**SUBJECT: DEMONSTRATION / DELIVERY HOLD – Compliance Recall 15C09 –
*Supplement #3***

Certain 2011-2013 and 2015 Model Year F-650 / F-750 Vehicles with 70% Fixed Seat
Front Passenger Fixed Seat Restraint Anchorage Point

REASON FOR THIS SUPPLEMENT

Provide revised technical instructions for the installation of the inboard restraint relocation bracket.

FIGURE 6

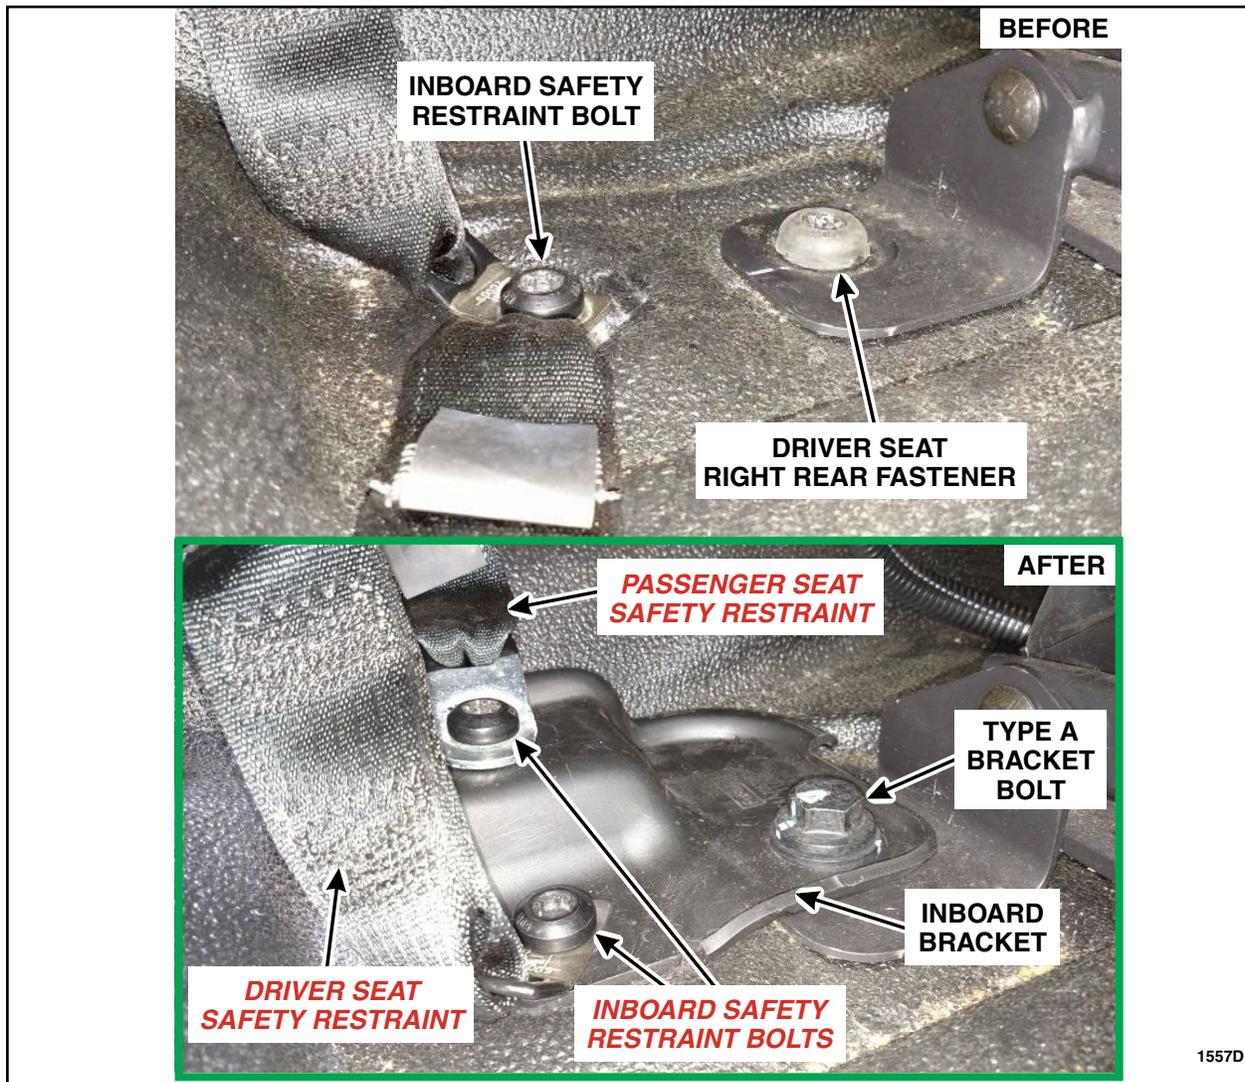
5. Install the inboard bracket (See Figure 6):

a. Remove and discard the driver seat right rear fastener.

NOTE: If the driver seat right rear fastener is secured with a stud and nut, the stud must also be removed and discarded.

b. Remove the inboard safety restraint bolt. This bolt will be reused for inboard bracket installation.

c. Install the inboard bracket with a new type A bracket bolt in place of the original seat fastener and tighten to 41 lb.ft (55 Nm).

d. Reusing the inboard safety restraint bolt, install the driver seat safety restraint **IN THE ORIGINAL LOCATION** and tighten to 30 lb.ft (40 Nm).

e. Install the passenger seat safety restraint and new restraint bolt to the relocation bracket and tighten to 30 lb.ft (40 Nm).

NOTE: Verify the safety restraint webbing is not twisted before fastening the safety restraints to the bracket.
